Consultant Advice Notice

From	Vickie Huang	Advice No	CAN-ESD-01
Project No	MEL4828	Project Name	Alfred Quarter
Date	28/04/2026	Pages	2
Subject	Daylight Memo	Revision	R02

Daylight Comparison

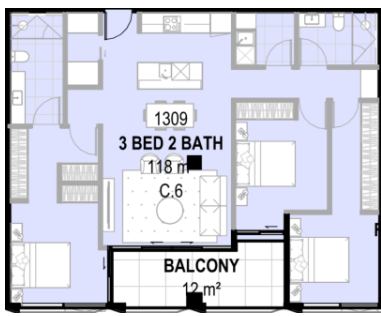
Old Scheme	New Scheme	Comment
		<p>Level 13</p> <p>The daylight performance for Bedroom 3 within the Level 13 unit type is also expected to improve due to the reduced balcony inset, allowing increased daylight penetration into the bedroom.</p>

Table 2: Precinct 2

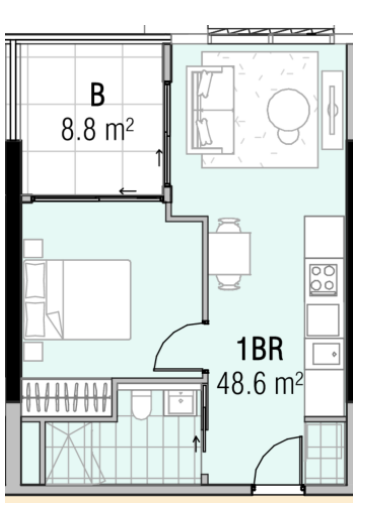
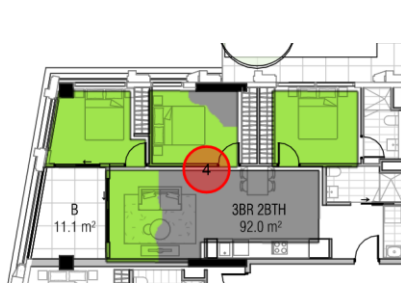
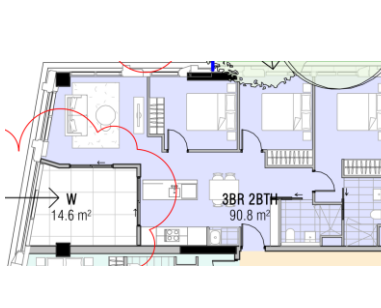
Old Scheme	New Scheme	Comment
		<p>Level 4</p> <p>The relocation of the living room to the façade line will result in improved daylight to the living room space.</p>
